AMENDMENTS TO THE DRAWINGS

This paper is filed in response to the Office Action mailed on 15th November 2006. Claims 1-21, 23 and 25 were pending in the application. Claims 7-11 and 14-17 were withdrawn from consideration by a restriction requirement dated 21st July 2006. No claims have been amended or added. Therefore, claims 1-21, 23 and 25 are now pending in the application and are submitted for reconsideration.

Figure 2

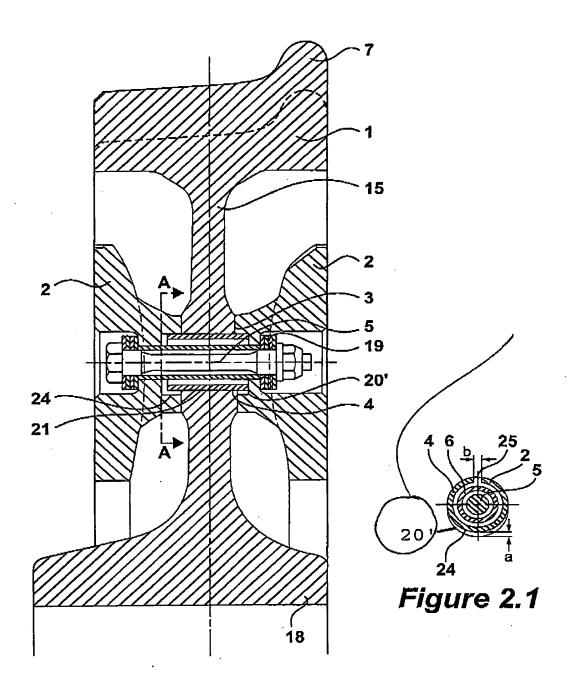
Amended drawing pages 2/9, 6/9, 7/9 and 8/9 are presented with this paper. Specifically FIG. 2.1 has been amended to include reference numeral 20°. This feature has been previously referenced in FIG. 2.

The description has also been objected to for failing to disclose the "elliptical or oval bore" of claim 13. This feature is in fact shown in Figure 2 and is discussed at page 9, line 9.

The "elliptical or oval bore" is now shown in FIGS 2 and 2.1 by feature 20' according to the replacement sheet attached hereto.

Working Cory
7/9

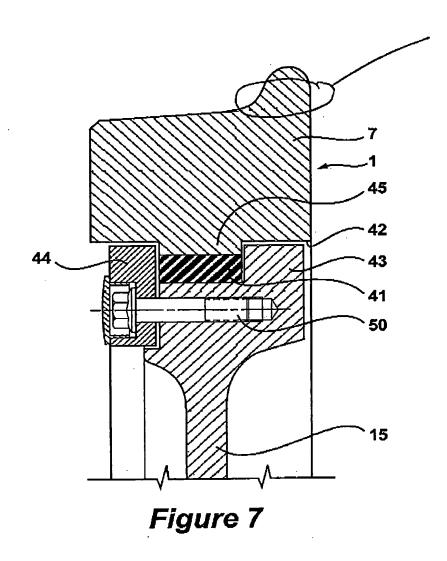
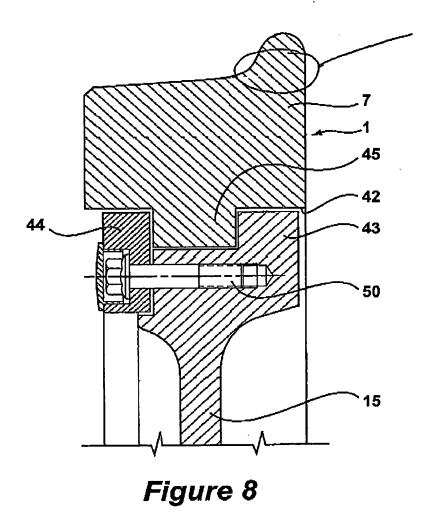
FIGS 7, 8 and 9 have been amended to remove the solid line in the rim flange.

Additionally, FIGS 1-4 were objected to for failing to identify the dotted line profile in the rim of the wheel. This line has now been defined in the description. Furthermore FIGS 7-9 were objected to for failing to identify the solid line in the rim. This line has now been deleted. An amended version of FIGS 7-9 is attached as described above.
